THE CITY OF SAN DIEGO TO THE PARK AND RECREATION BOARD

REPORT NO. 104

SUBJECT: Ocean Beach Veterans Plaza Park General Development Plan

THE GENERAL DEVELOPMENT PLAN

PROPOSED VETERANS PLAZA IMPROVEMENTS
SCALE: 1" = 10'-0"

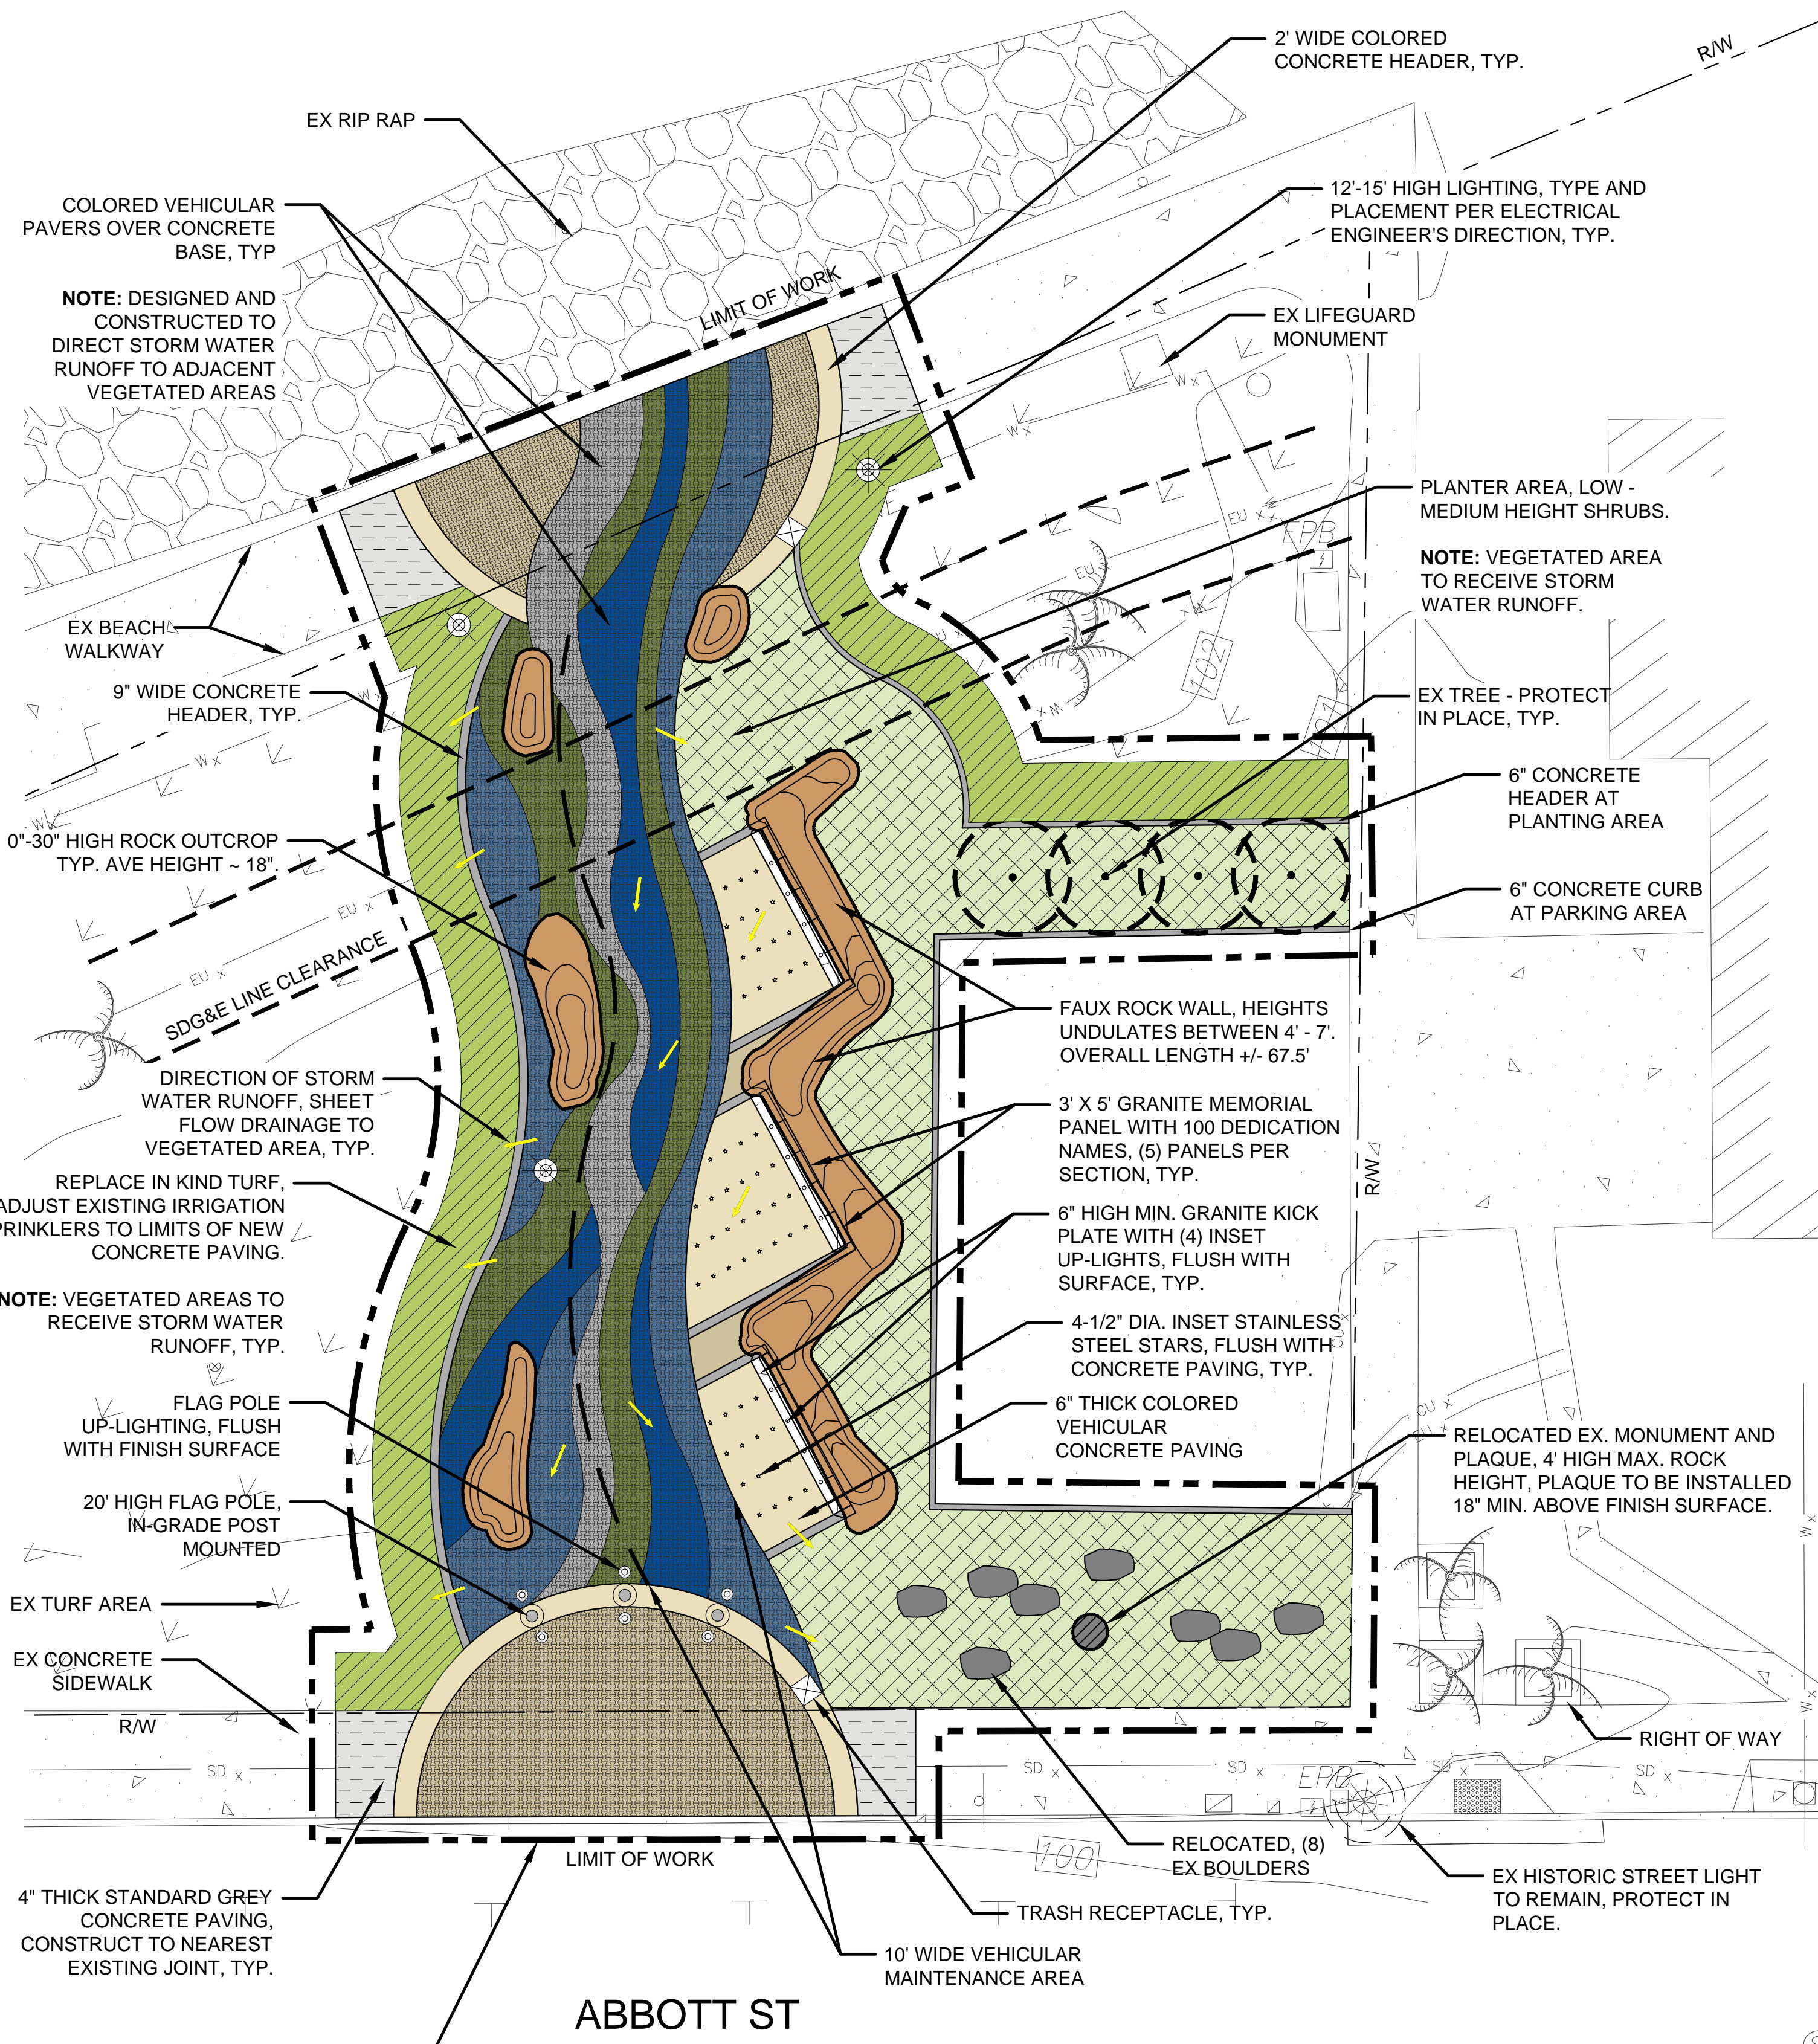
2. Being located near the beach, children may climb on rock walls. Recommend checking into the liability of placing a structure like this in a public space.

3. The rock wall finish must be such that graffiti can be easily addressed without sacrificing the aesthetic of the walls.

4. Pay careful attention to the colors used in the paving and avoid trendy color schemes.

5. All materials must be durable due to the site's location. Tidal surges could reach the improvements.

6. Consider adding trash cans along the walkway.

7. The beachside Plaza ends abruptly. Study other ways to address this end of the walkway.

8. The rock wall seems to be rather abrupt. It should appear to grow out of the ground, tapering down at the west end and wrapping around the corner on the east end.

9. Use an integral color for the rock wall.

Response: The faux rock memorial wall varies in heights from 4'– 7'. Faux rock outcrops, located along the central pathway, vary in height, with an average height of 18" and a maximum height of 30" (same as typical seat-wall in public space). The faux rock outcrops provide seating, function as a visual transition to the larger memorial wall.

Response: Anti-graffiti coating will be applied to all faux rock.

Response: Paver colors have been selected to match the Armed Force uniform colors e.g. Navy, Army, Air force, Marines, etc.

Response: Pavers will be of vehicular grade over concrete base to prevent settling of individual pavers. In the event of a tidal surge, the plaza area is protected by an existing rip rap buffer between the beach and walkway. Any tidal conditions drawn over the rip rap should sheet flow over the plaza surface. The faux rock wall will be structurally calculated and reinforced per structural drawings. Plant material is tolerant to salt spray and has been known to persist in coastal climates.

Response: The design includes two trash receptacles, one at the entrance along Abbott Street and a second along the beachside walkway entrance. There are also existing trash receptacles along the existing walkways.

Response: The 2'0" wide concrete band, circular entry forms, and "river of life" pavers transition the existing walkways to the Plaza circulation.

Response: In considering public safety and deterring climbing of the main wall, the faux rock wall in the Plaza will start at 4' and rise to 7'. The faux rock benches will be 12" to 18" high, similar to the height of typical benches.

Response: The shotcrete material will be an integral color concrete which is neutral in tone between the desired low and highlight colors. The highlight colors will be stains, which will penetrate into the shotcrete pores and then a sealer will be applied.

PHYSICAL MODEL SCALE: 1" = 1'-0"

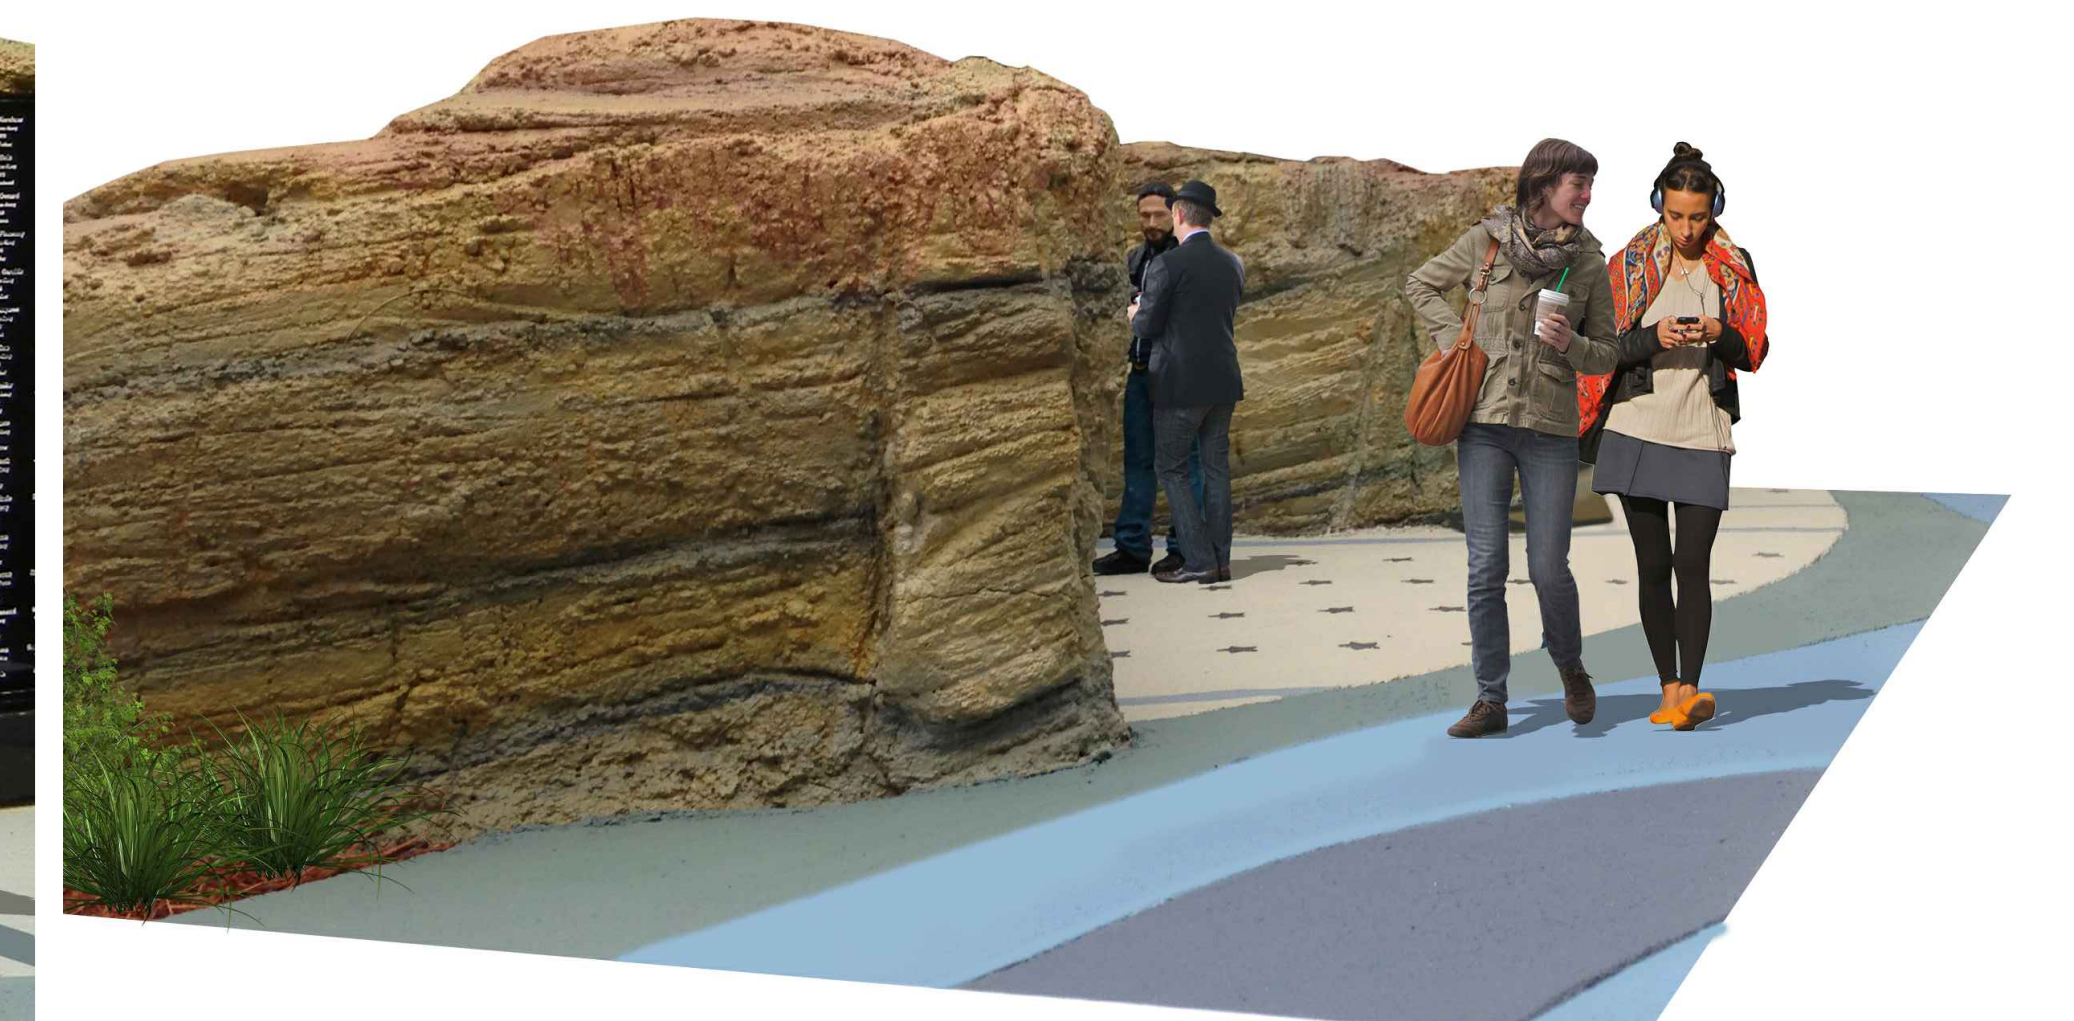
10. Suggest a scaled model of the rock wall to ensure it provides the desired effect and keep an open mind in its design. This is a significant feature of the memorial and must be done correctly to be effective.

Response: A 1"=1'-0" scale model was created to illustrate a terminal end of the wall and its transitions to adjacent memorial panel section. A depiction of the model is shown on Attachment 2.
